REGIONAL REVIEW NOTICE

ARC REVIEW CODE: R9072001

Name of Proposal: TreatMed Biomedical Waste Treatment Facility

TREATMED BIOMEDICAL WASTE TREATMENT FACILITY DRI
City of Fairburn
Environmental Planning Division Review Comments

LAND DISTURBANCE PLANS FOR TREAT MED BIOMEDICAL WASTE TREATMENT FACILITY
LOCATED IN LAND LOTS 1062, 2ND DISTRICT, 1ST SECTION CITY OF FAIRBURN, GEORGIA
SITE PLAN

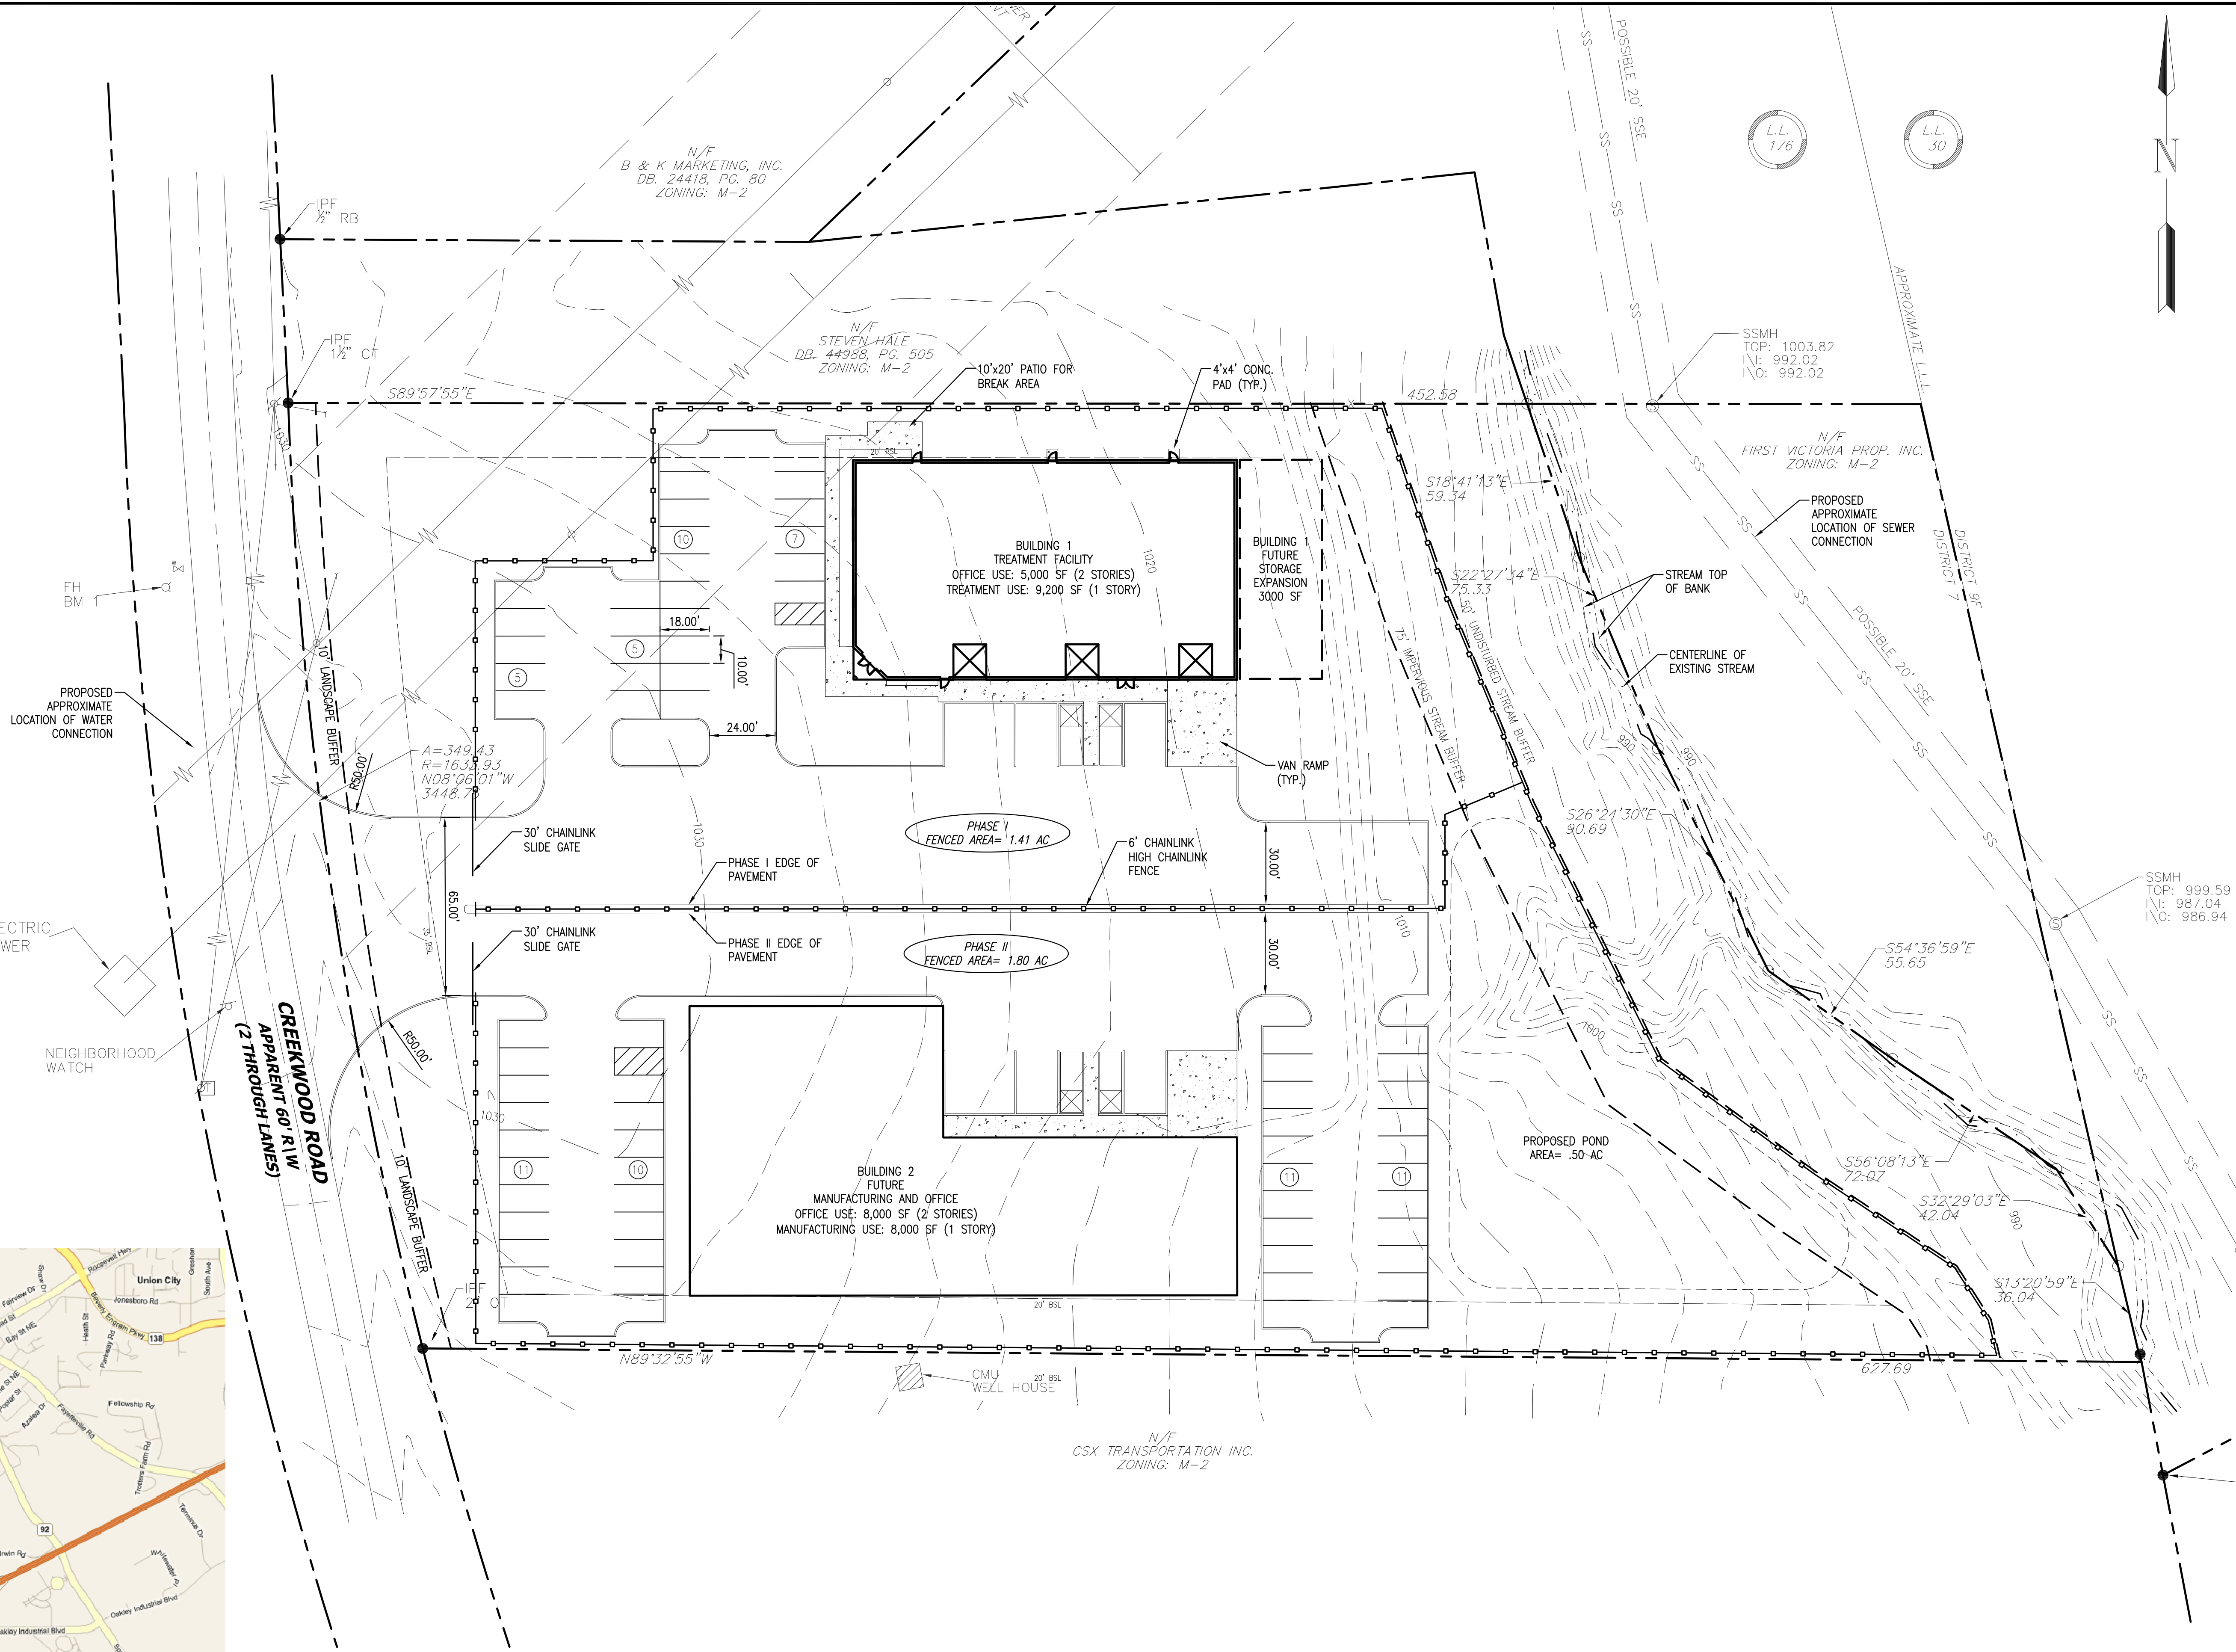
There are no perennial (blue-line) streams on the property, based on the USGS coverage for the area and no water supply watershed buffers are required. The site plan shows a 75-foot stream buffer on the property, which is consistent with the District Model Stream Buffer ordinance and is presumably consistent with the City of Fairburn stream buffer ordinance. Additionally, all state waters on the property will also be subject to the Georgia Department of Natural Resources (DNR) 25-foot erosion and sedimentation control buffer.
